**REGENCY EXECUTIVE PARK SUBDIVISION,**  
**UNIT THREE RESUBDIVISION OF LOT 2**

The plat illustrates the proposed 2 lot, 14.7 acre  $\pm$  subdivision which is located on the South side of Grelot Road, 225'  $\pm$  West of University Boulevard, and is in Council District 6. The applicant states that the subdivision is served by both public water and sanitary sewer.

The purpose of this application is to resubdivide a legal lot of record that was originally approved by the Planning Commission on February 3, 2000, into 2 legal lots of record.

# DETAIL SITE PLAN

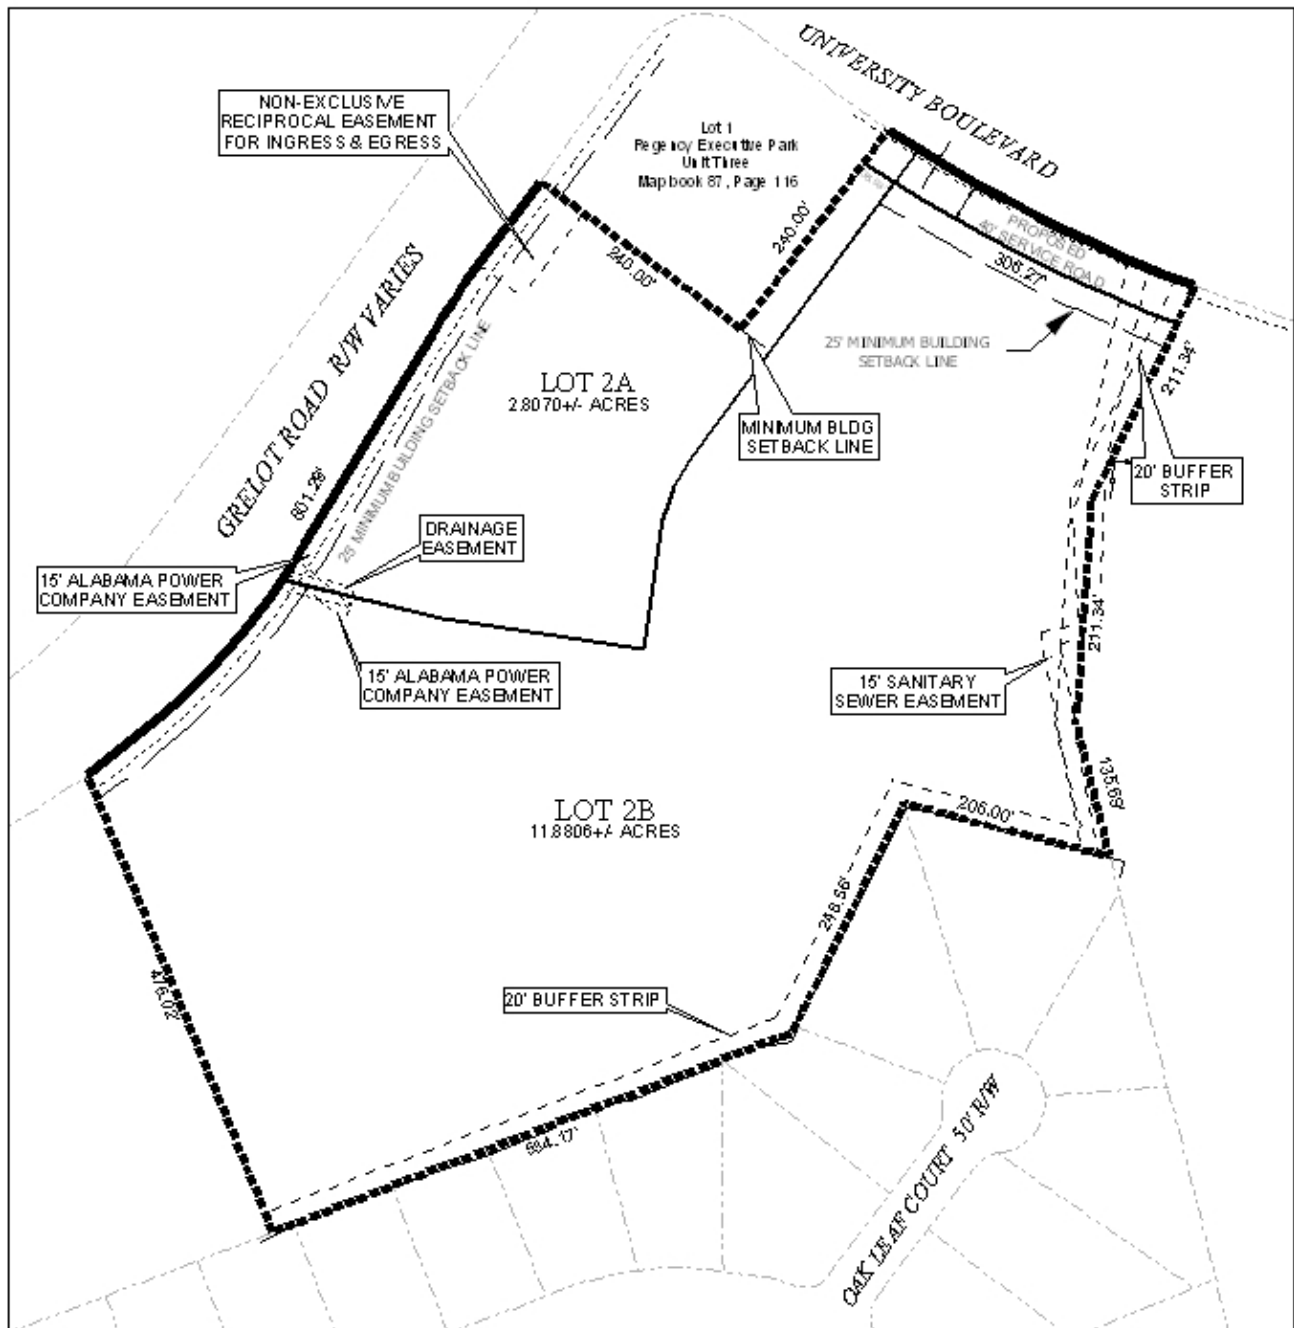
The proposed Lot 2A is illustrated as a flag lot. The proposed lot has approximately 457 feet of frontage along Grelot Road. The plat also illustrates a 35-foot wide "flagpole" from the lot to University Boulevard, presumably for access to University Boulevard. This "flagpole" seems uncharacteristic of lots in the area.

Both University Boulevard and Grelot Road are planned major streets on the Major Street Plan Component of the Comprehensive Plan. The plan requires a 100-foot right-of-way for each major street. Adequate right-of-way exists for both streets, and, as such, no further dedication should be required. The plat is depicting a 40-foot Service Road along the University Boulevard frontage. No service roads currently exist in this area of University Boulevard, and, further, both of the parcels immediately to the north and south of this site are already developed. That being stated, there would seem to be no reason to construct a service road that will only be 341 feet

long and has little, if any, possibility of ever being extended. It is recommended that the service road that is depicted be deleted.

For the proposed Lot 2A, access should be limited to one curb cut to Grelot Road with the size, location, and design of the curb cut to be approved by City of Mobile Traffic Engineering and conform to AASHTO standards. A precedent has been set for a lot of this size being limited to one curb cut as the West Regional Library adjacent to this site is a larger lot, has more frontage, and has only one curb cut. Access to University Boulevard from this lot is another matter. Presumably, the reason for the “flagpole” from the bulk of the proposed lot to University Boulevard is for access. It is likely that the applicant intended to use the proposed service road for access instead of having both lots access University Boulevard directly. As stated earlier, there is no reason to build a public street of such minimal proportions, and this report has already recommended deletion of the service road from the plat.

The recommended deletion of the service road would require the proposed Lot 2A to access University Boulevard directly. The Chevron station at the corner of University and Grelot has a driveway egress onto University Boulevard approximately 20 feet from the proposed property line. Additionally, the proposed Lot 2B of this subdivision has adequate frontage along University Boulevard to warrant a curb cut. Considering the daily traffic counts for University, as well as the proximity of the existing curb cut from the Chevron, it would seem that direct access to University from this proposed lot would be unsafe and improper. Therefore, the proposed Lot 2A should be denied access to University Boulevard. Denying access to University Boulevard would eliminate the need for the “flagpole” portion of the lot, and the plat should be revised to reflect the deletion of the “flagpole” for the proposed Lot 2A.

The 25-foot minimum building setback line is depicted correctly for both lots along Grelot Road. Because the “flagpole” portion of the lot is recommended for deletion, the setback line should be revised to reflect the new lot orientation.

- 1) Retention of the labeling of the size of the lot, in square feet, or provision of a table on the plat with the same information;
- 2) Deletion of the proposed 40-foot service road right-of-way;

- 3) Elimination of the “flagpole” portion of Lot 2A;
- 4) Retention of the 25-foot minimum building setback along Grelot Road and revision of the 25-foot minimum building setback along University Boulevard to reflect the new lot orientations;

- 5) Placement of a note on the final plat limiting Lot 2A to one curb cut to Grelot Road and limiting Lot 2B to one curb cut to Grelot Road and one curb cut to University Boulevard, with the size, location, and design of all curb cuts to be approved by City of Mobile Traffic Engineering and conform to AASHTO standards;

- 6) Placement of a note on the final plat stating that there be no direct connection between University Boulevard and Grelot Road via Lot 2B;
- 7) Provision of a 20-foot buffer to remain in its natural vegetative state where the site abuts residentially zoned property;
